Data on $\text{OMA}_{\text{outer}}$ and correlation with $\text{OMA}_{\text{TDECQ}}$

- related to comments #69 and #218

Roberto Rodes, Coherent

802.3dj interim

Comment 218. Clarifying OMA_{outer} definition in Draft 3.0

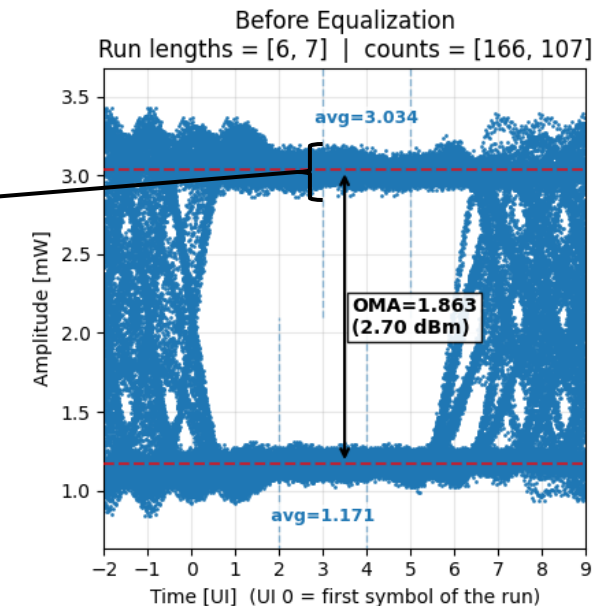
Cl 180	SC 180.9.5	P 476	L 42	# 218
Maniloff, Eric		Ciena Corporation		
Comment Type	TR	Comment Status	D	OMA_{outer} (OI)
OMA_Outer with pattern 6 (SSPRQ) has multiple runs of = 7 threes and = 6 zeroes. In order to obtain consistent measurements, all runs of 7's and 3's should be measured.				
Suggested Remedy				
Change text to: δWhen measured with pattern 6, OMA_{outer} is measured as the difference between the average optical launch power level P_3 , measured over the central 2 UI of the first 7 UI of all runs of 7 threes or more, and the average optical launch power level P_0 , measured over the central 2 UI of the first 6 UI of all runs of 6 zeroes or more.δ. Make similar change in clause 181.9.5, 182.9.5, and 183.9.5

- Unclear whether P_3 is defined from:
 - a single run of 7 threes, or
 - the average across all 107 runs in SSPRQ
- Large variation between individual runs
- Averaging across all runs improves measurement stability
- David Leyba (affiliated with Keysight): “current implementation averages across all runs”

Comment 69. Replace OMA_{outer} with OMA_{TDECQ} in Eq 180-12

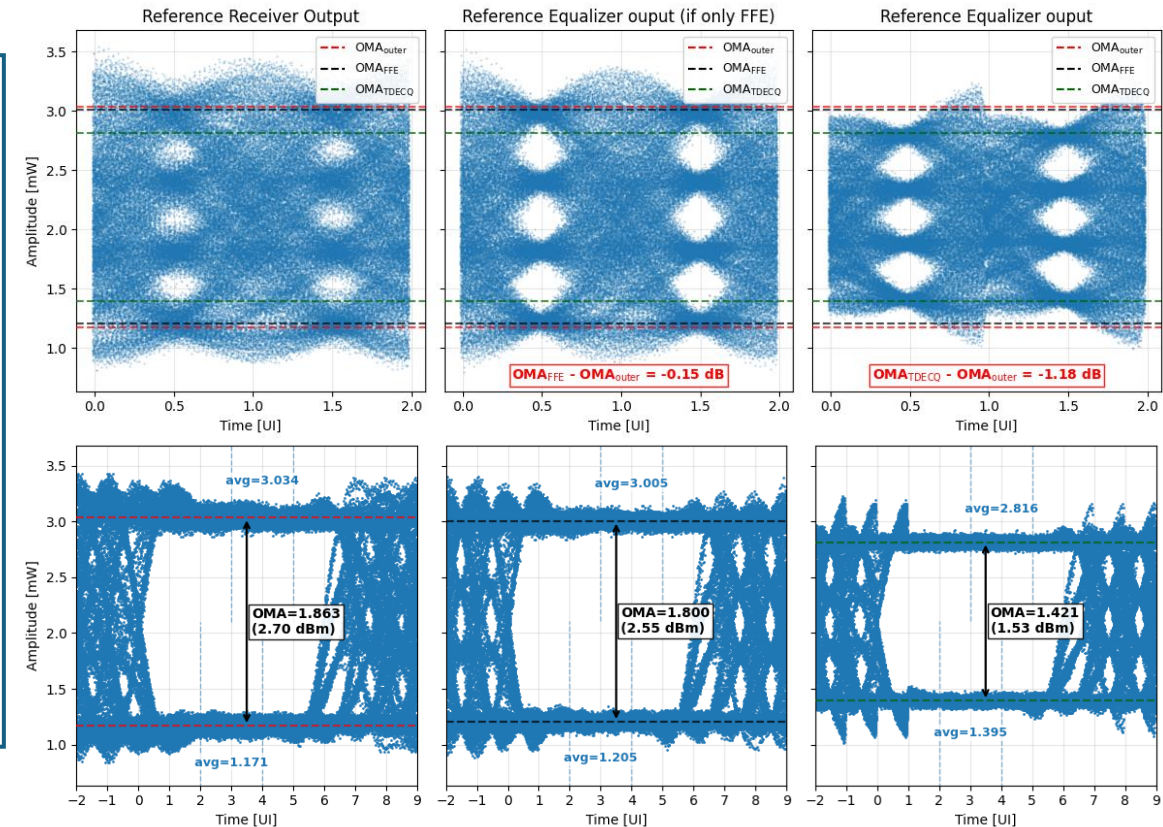
- The proposed remedy suggests using OMA_{TDECQ} instead of OMA_{outer} in the TDECQ calculation.
- OMA_{TDECQ} and OMA_{outer} are not equivalent measurements, and the introduction of DFE increased the difference between them.
- In Eq. 180-12, the receiver noise term R is added before the reference equalizer, therefore, OMA term should be measured before reference equalizer to remain consistent.
- Redefining OMA_{outer} to be measured after the reference equalizer is beyond the scope of this comment, and should consider impact on extinction ratio, overshoot, and RIN.

OOMA measurement location for TDECQ was changed in draft 2.4 to the reference equalizer input waveform. Input waveform tends to be unstable before the equalizer. OOMA measurement location should be verified using data from real transmitters, not just simulations.

Suggested remedy: Change OMA_{outer} definition in equation 180-12 from " OMA_{outer} is measured as defined in 180.9.5" to " OMA_{outer} is measured as defined in 180.9.5 except using waveforms captured at the output of the reference equalizer".
